## FIELD CHANGE ORDER

TU77A

0007

THIS REVISED FCO SUPERSEDES THE ORIGINAL RELEASE OF 15 MAY 1981. IT PROVIDES THE FOLLOWING CORRECTIONS: ON PAGE 11, REWORK STEPS 39 AND 40 WERE ADDED.

Figure 6-7 Forward Start Ramp

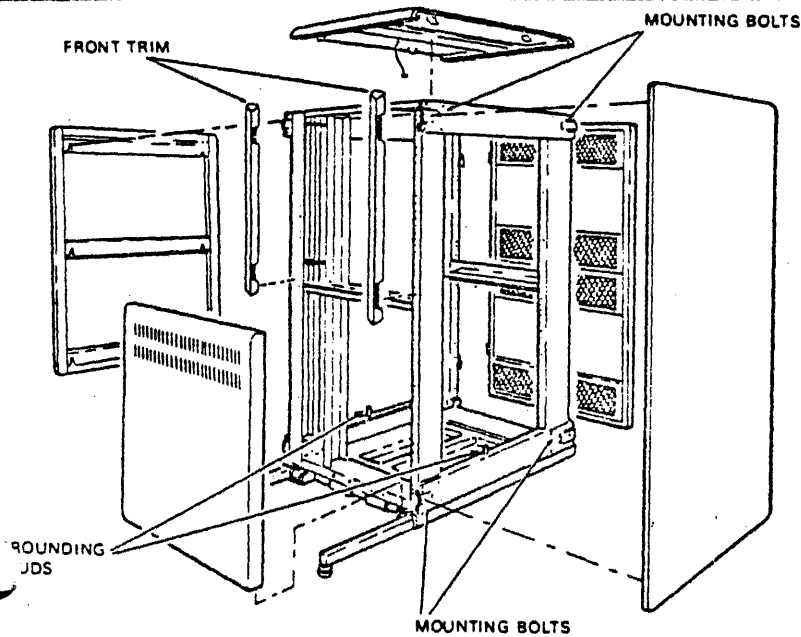
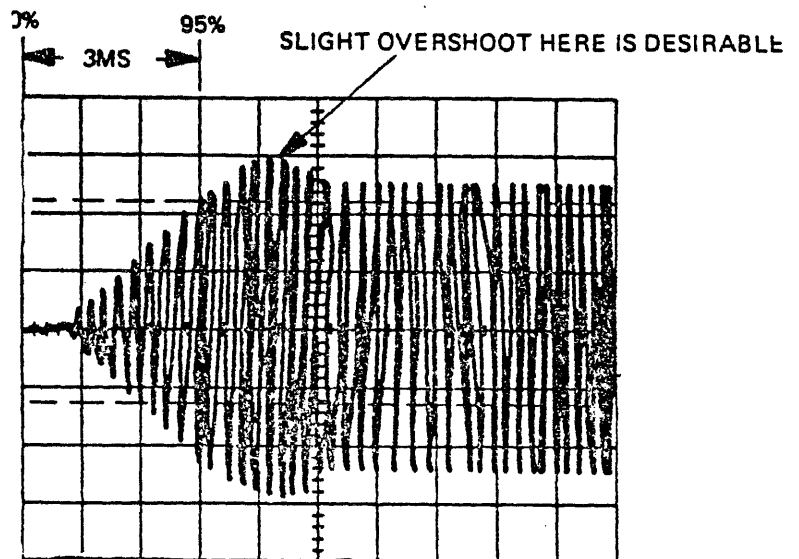
- PAGE 6-16, FIGURE 6-7 FORWARD START RAMP  
DELETE OLD FIGURE 6-7 AND INSERT NEW FIGURE 6-7.
- PAGE 6-32, 6.5.8.1 NRZI THRESHOLD ADJUSTMENT  
IN STEP 6, CHANGE THE VOLTAGE RANGES TO:  
+1020 MV MAXIMUM  
+780 MV MAXIMUM  
IN STEP 7, CHANGE THE VOLTAGE READING TO 900 MV.
- PAGE 6-66, TABLE 6-15 DATA L READ THRESHOLDS  
CHANGE THE NRZI READ LOW THRESHOLD VOLTAGES TO:  
TP69 +900 MV +120 MV  
TP70 -900 MV ±120 MV

FIGURE 1

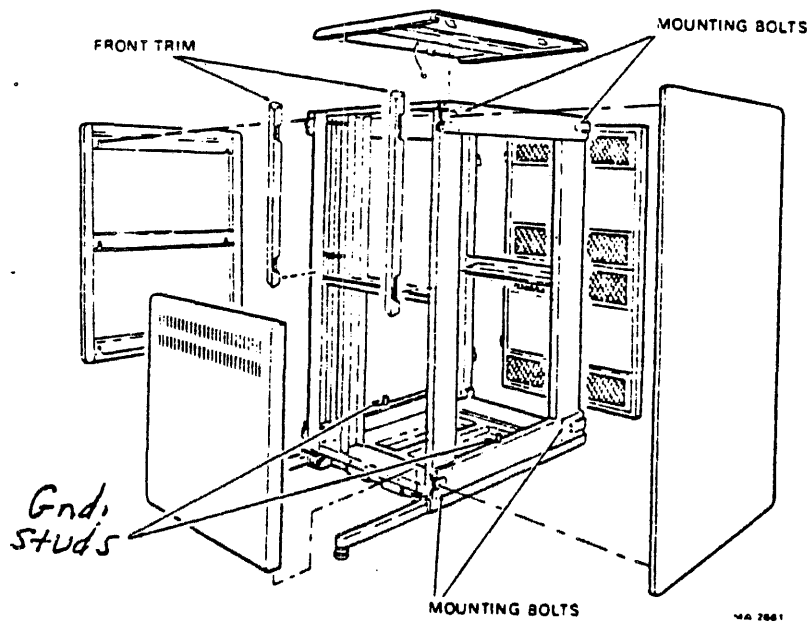
THE TU77 MANUALS DO NOT MENTION THE INSTALLATION OF THE GROUND STRAP, PN 74-12827-25 WHICH IS SHIPPED WITH EVERY SYSTEM.

THE STRAP SHOULD RUN FROM ONE OF THE GROUND STUDS ON EITHER LOWER SIDE STRUT TO THE HOST CPU. SEE FIGURE 1. THE MANUALS WILL BE CORRECTED.

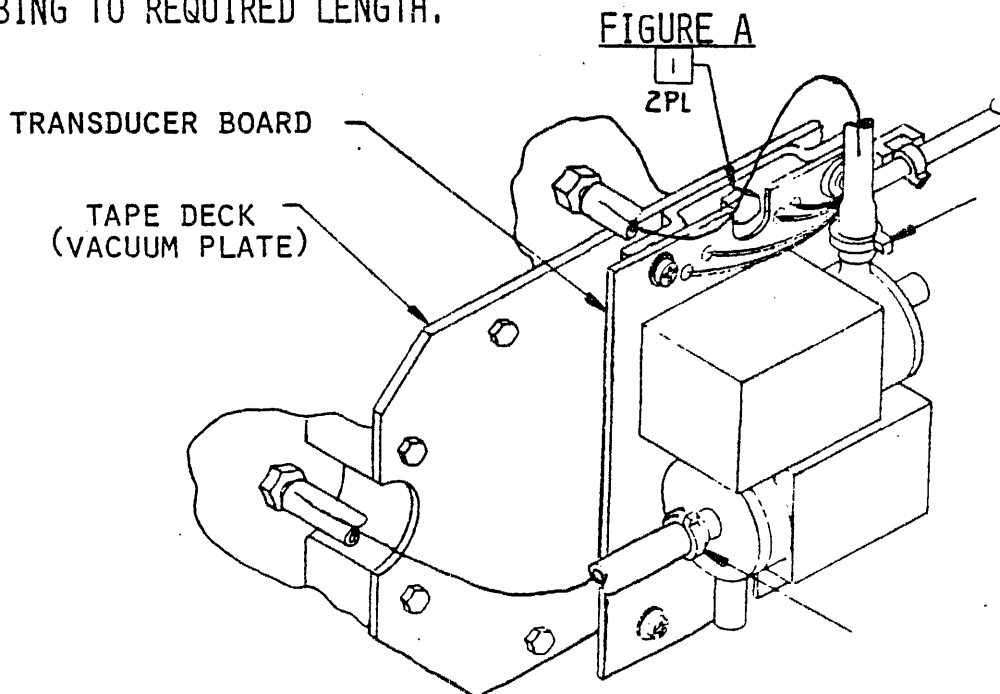
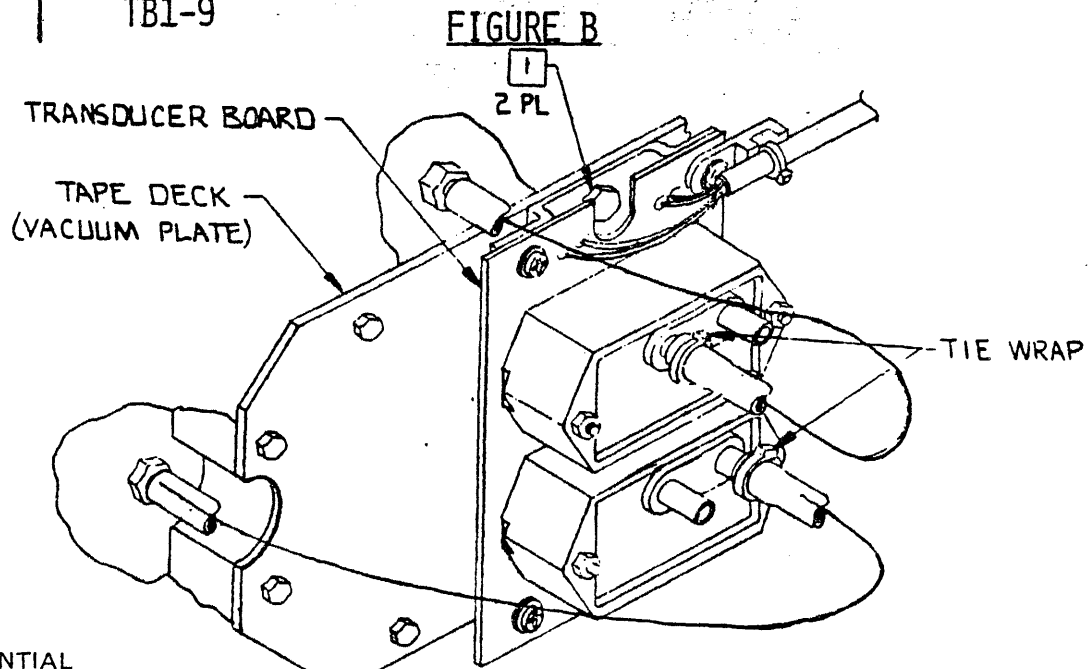
THERE IS A NEW TYPE OF TRANSDUCER ASSEMBLY BEING INTRODUCED BY PERTEC. IT IS COMPLETELY INTERCHANGEABLE WITH THE PRESENT ONE. THE PART NUMBER 29-23246-00 WILL NOT CHANGE.

1. REMOVE TRANSDUCER BOARD, PNEUMATIC TUBING, AND WIRING (SEE FIGURE A) DISCARD. SAVE EXISTING HARDWARE. (SEE #1 OF FIGURE A)
2. INSTALL NEW TRANSDUCER ASSEMBLY WITH EXISTING HARDWARE.
3. CONNECT PNEUMATIC TUBING AND TIE WRAPS AS SHOWN IN FIGURE B. CUT TUBING TO REQUIRED LENGTH.

4. CONNECT CABLE PER WIRING LIST.
5. DO TAPE LOOP POSITION ADJUSTMENT.

FIG 1

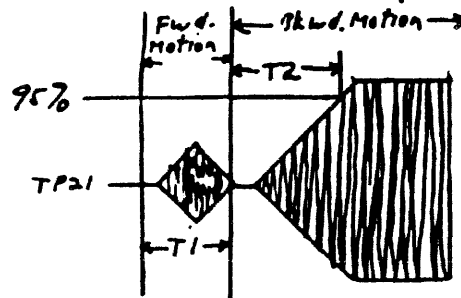
With the Rev G change to the M2 module, 29-23774, a logic change is being incorporated in the TU77. This additional logic adds what is referred to as a "Forward Hitch", when a reverse tape motion is attempted after a delay of 10 to 20 ms.

For the TU77, this logic also changes the waveform that is seen during capstan ramp adjustment on Pin 21 of the Rev G and above M2 module. Fig. 1 shows the waveform that will be seen on TP21 with this change installed.

T2 time frame, which is the actual backward start ramp, is adjustable and should be 3.0 ms ± .15 ms (2.85 - 3.15 ms).
